## **INQUIRY INTO MUSEUMS AND GALLERIES**

**Name:** Dr John Macintosh

Re: Museums and galleries in New South Wales, First Report, 18 December 2017

Figure 8 Flood Extents through the study area

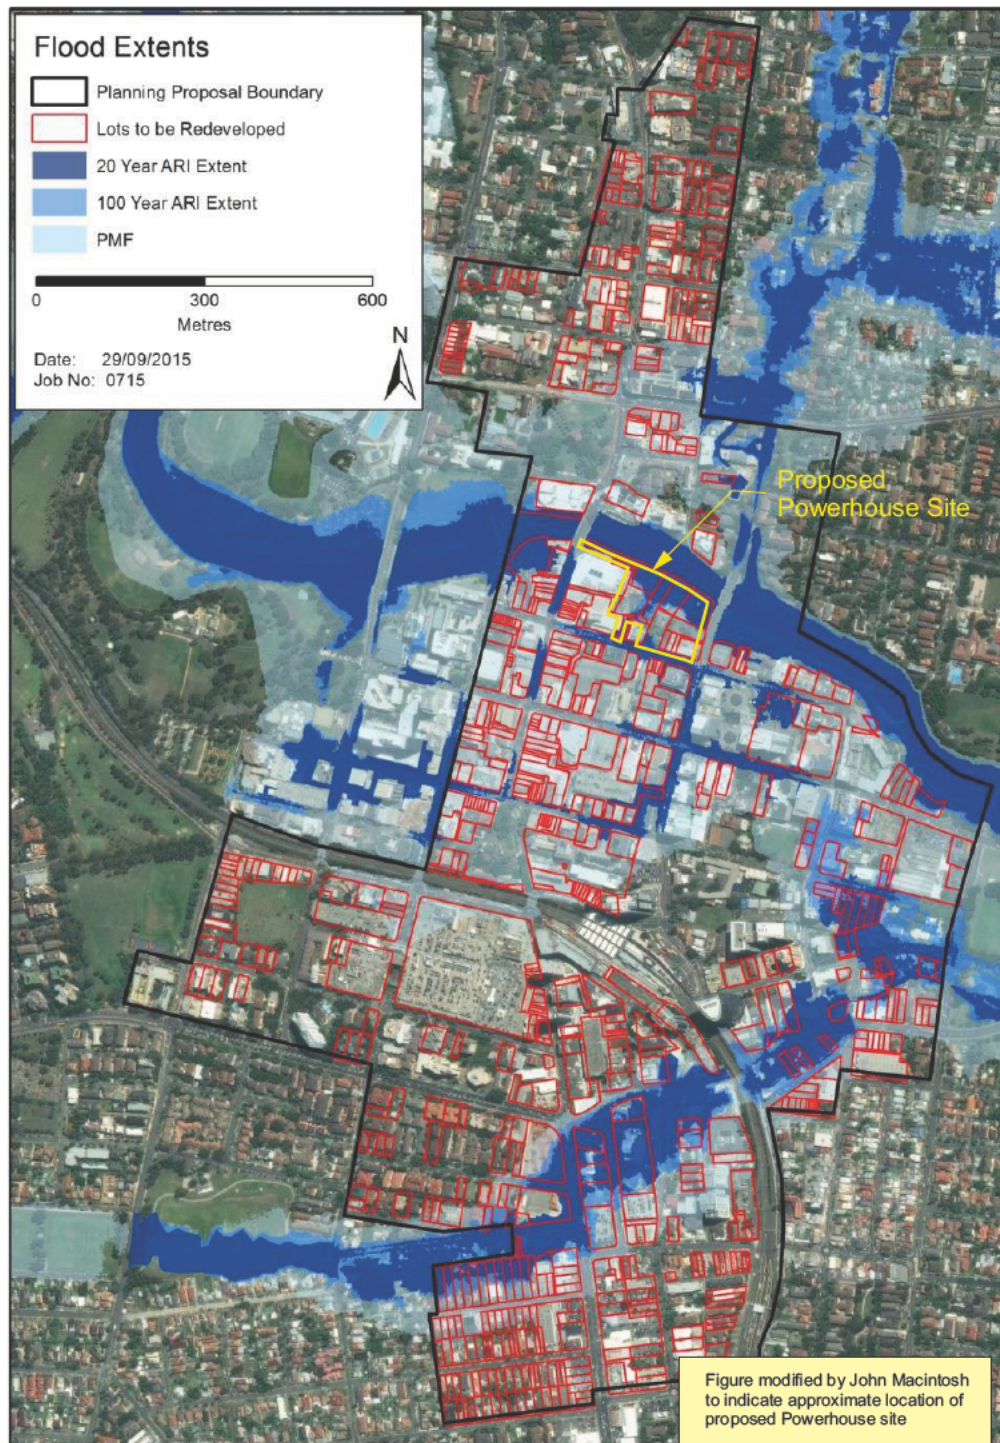
The attached Figure 8 was copied from MS2016 and modified to show the approximate location of the proposed PHM site. This figure indicates the extents of inundation within and around the proposed PHM site for flooding events of 20 Year ARI, 100 Year ARI and PMF.

It is significant to note that a fair portion of the site is affected by the 20 Year ARI event, as too are the roads/laneways/footpaths within and around the site.

In considering the above I conclude that locating the PHM at the proposed site would result in visitors to the PHM being exposed to unacceptable flood hazard.

Figure 9 Flood Hazard Precincts

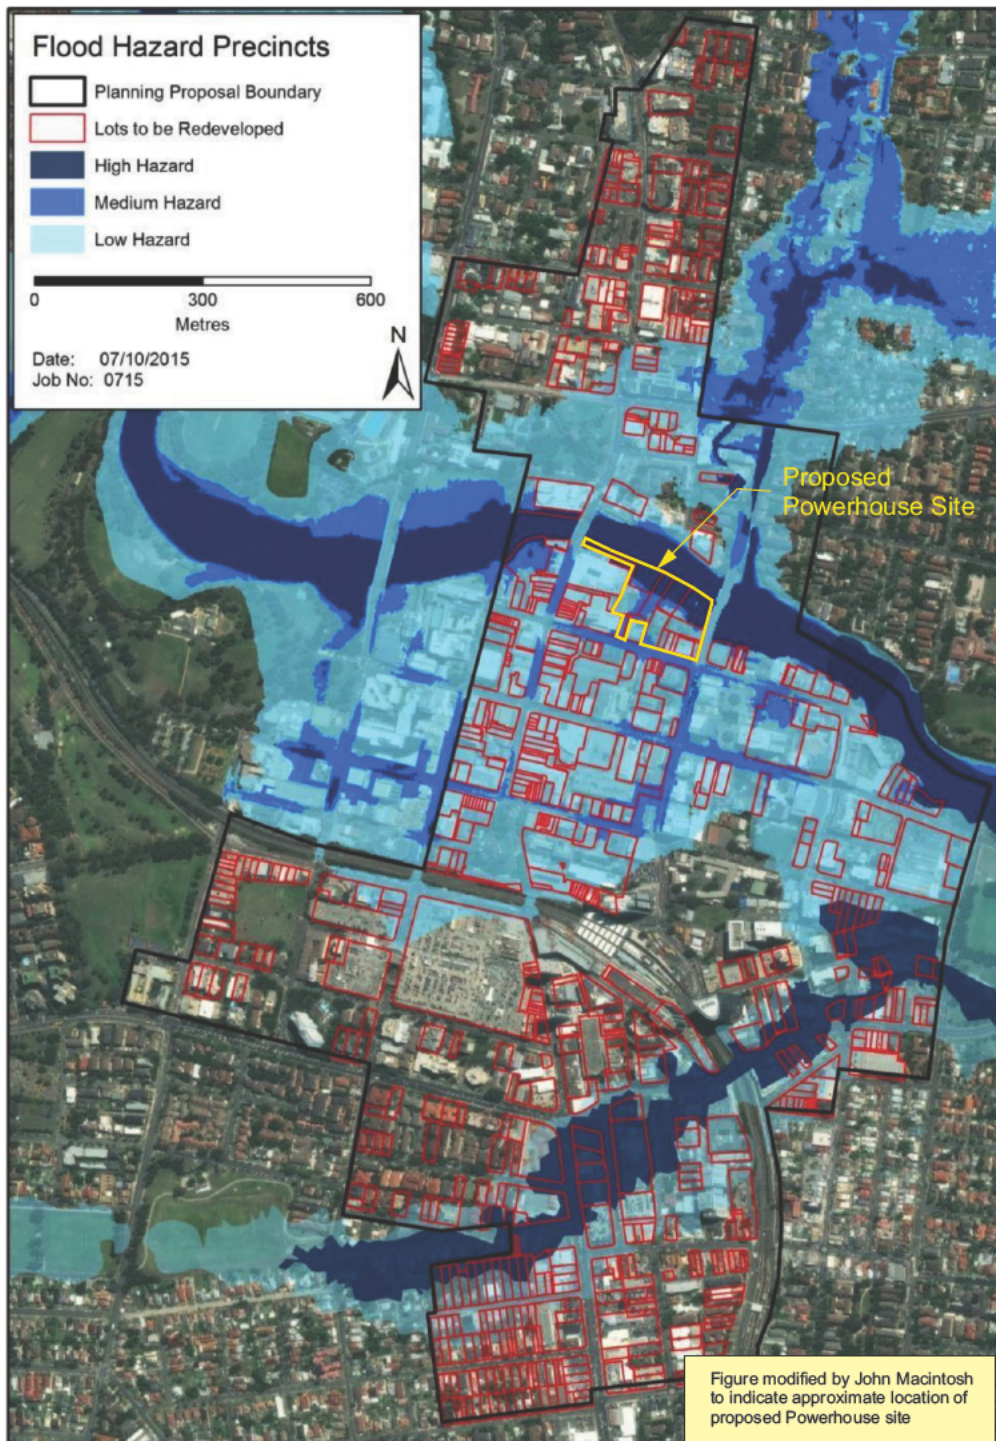
The attached Figure 9 was copied from MS2016 and modified to show the approximate location of the proposed PHM site. Please note the blue shaded legend depicting flood hazard. The overall

spatial extent of hazard, as shown on Figure 9, corresponds to the estimated Probable Maximum Flood (PMF) flooding extents. That is, all areas affected by PMF inundation are classified with a *Low Hazard* classification, at least. Within and around the proposed PHM site, flood hazard classification is seen to be *High* along the river frontage, and *Medium* within the internal road/laneways/footpaths.

It is of relevance to note that roads, laneways and footpaths tend to attract increased flood hazard classification. This is because these locations tend to become active overland flow paths during flooding events.

It is also of relevance to note that flood hazard classification is not so much related to the size of a flood (e.g. PMF, or 20 Year ARI) but instead, on what the water flow velocity and depth becomes when it becomes inundated.

Figure 10 PMF Depth Map

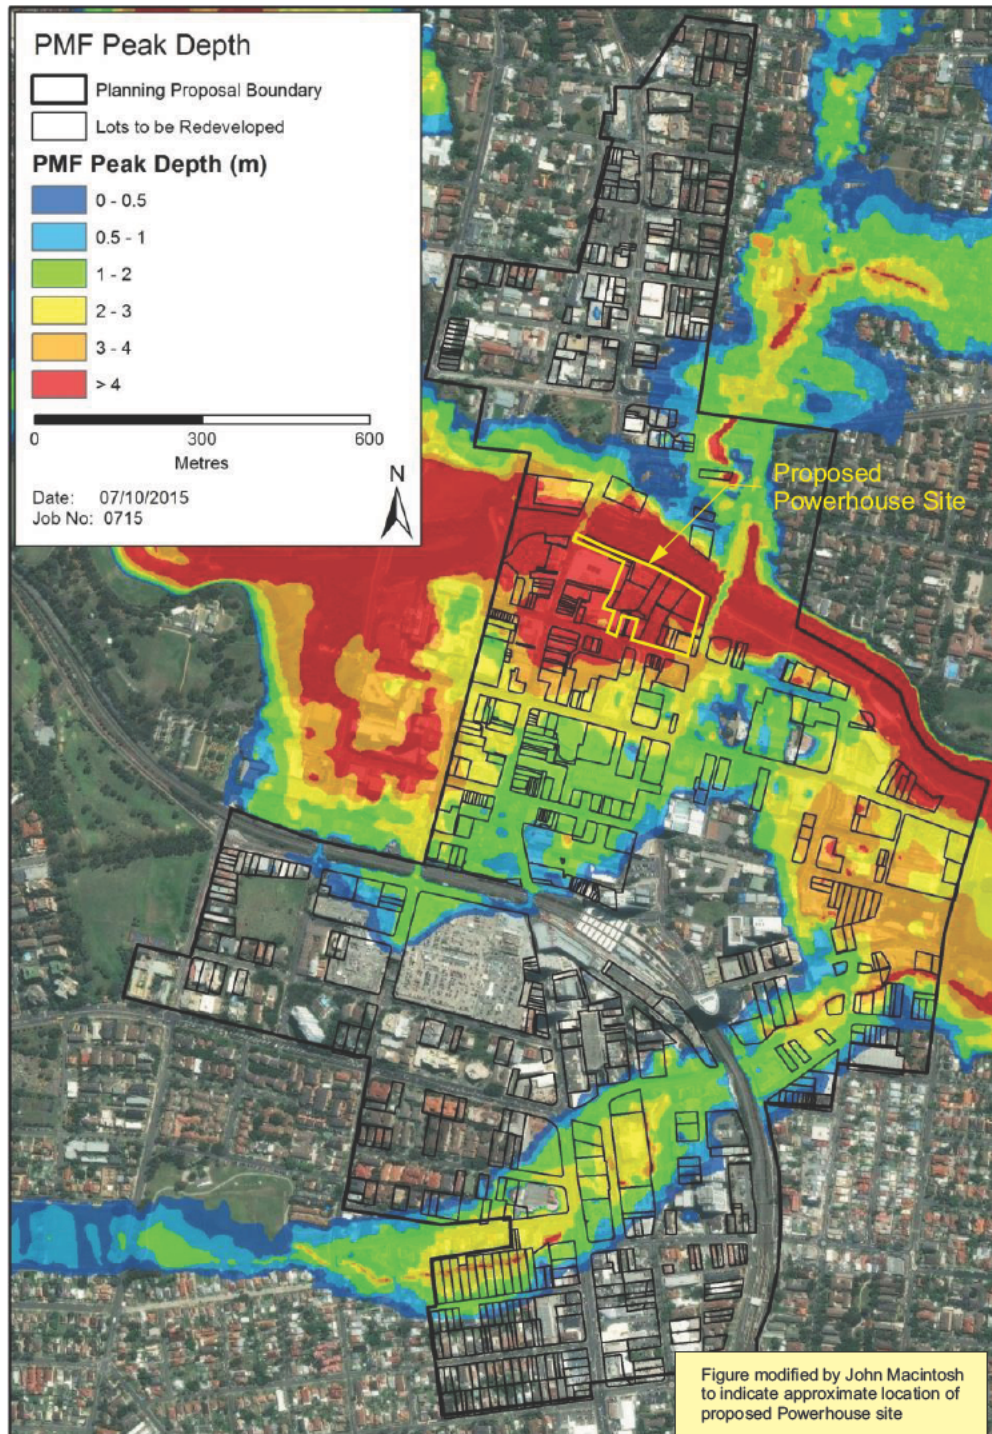
The attached Figure 10 was copied from MS2016 and modified to show the approximate location of the proposed PHM site. This figure shows the estimated depth of maximum inundation of the PMF above existing ground level. It is seen that the estimated depth of inundation within and around the PHM site is generally deeper than 4m. This is considerable.

Of course, water structures can be designed to exclude water to this depth, foundations can be sealed, watertight bulkheads can be installed, and a feasible business case may be put forward in justification.

However, despite the economics, there would remain good chance that the works would fail on at least one occasion during their life, through: human error, material failure, or occurrence of unexpected circumstances.

It therefore seems that the only viable consideration for a business case would be based around having the PHM complex constructed on top of piers extending above the level of the PMF. This, in my view, would not be a practicable solution.
